SUBJECT: C14T-03-0001 - Pioneer Hill TND - Conduct a public hearing and approve an ordinance amending Chapter 25-2 of the Austin City Code by zoning property locally known as East Dessau Road; located across the street from the intersections of Dessau Road and Applegate Drive, Dessau Road and Meadowmead Drive, and Dessau Road and Childress Drive (Walnut Creek Watershed) from interim-rural residence (I-RR) district zoning to traditional neighborhood (TN) district zoning. Zoning and Platting Commission Recommendation: To grant traditional neighborhood (TN) district zoning. Applicant: Estate of Fred C. Morse, Sr., Deceased (Scott N. Morse, Frederic C. Morse, III), JP Morgan Chase Bank, N.A. (Scott DeNeen), Milburn Homes, L.P./dba D.R. Horton Homes, L.P. (Dale Thorton). Agent: Milburn Homes, L.P./dba D.R. Horton Homes, L.P. (Dale Thorton). City Staff: Sherri Gager, 974-3057.

ZONING CHANGE REVIEW SHEET

CASE: C14T-03-0001

PIONEER HILL ZONING VARIANCES, CLARIFICATIONS & WAIVERS
CASE # C14T-03-0001

Ⓔ Mixed Residential Street (One Way Westbound)

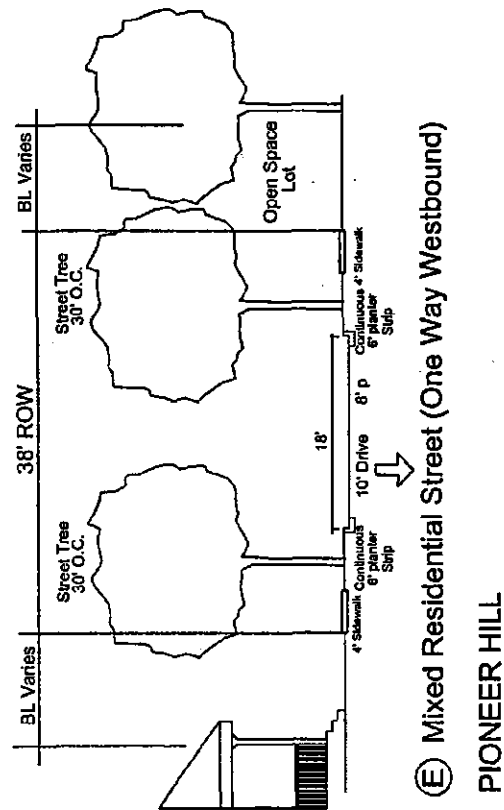
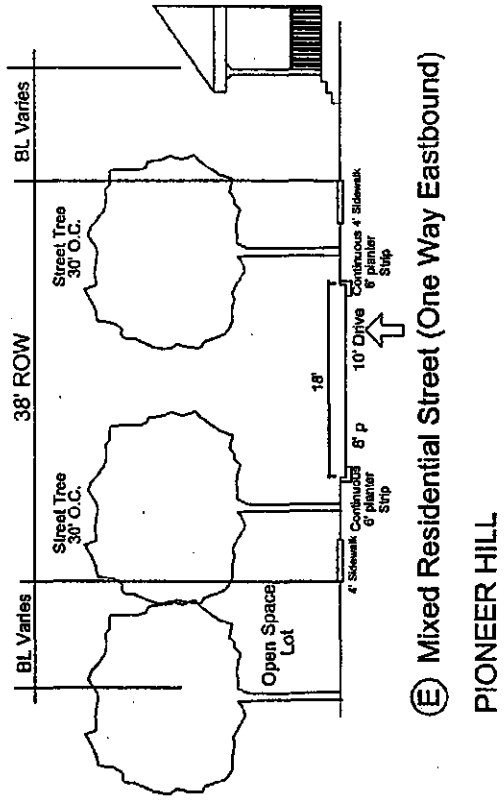
The applicant for the above referenced subdivision is requesting a variance to Title 25: Traditional Neighborhood District Criteria Manual Section 4.2 Street Classifications and Streetscapes Sections (TCM). The applicant requests the following change: A new street type, 4.2.3A Mixed Residential Street, which has a right-of-way width of thirty-eight (38) feet, parking permitted on one side and a paving section of eighteen (18) feet in one direction and four (4) foot sidewalks on either side.

Staff recommends approval of the variance for the following reasons:

- The cross section is similar to the existing Mixed Residential Boulevard. The change is requested so that a green space may be provide between the pavement sections and will serve as part of the hike and bike system that is present throughout the TND.
- The Transportation Planning and Sustainability Department (TPSD) has approved this proposed cross section.
- The use of the new cross section will be reviewed by TPSD during the subdivision process to ensure pedestrian safety, proper use of traffic controls, appropriate speed limit, and adequate design profiles.
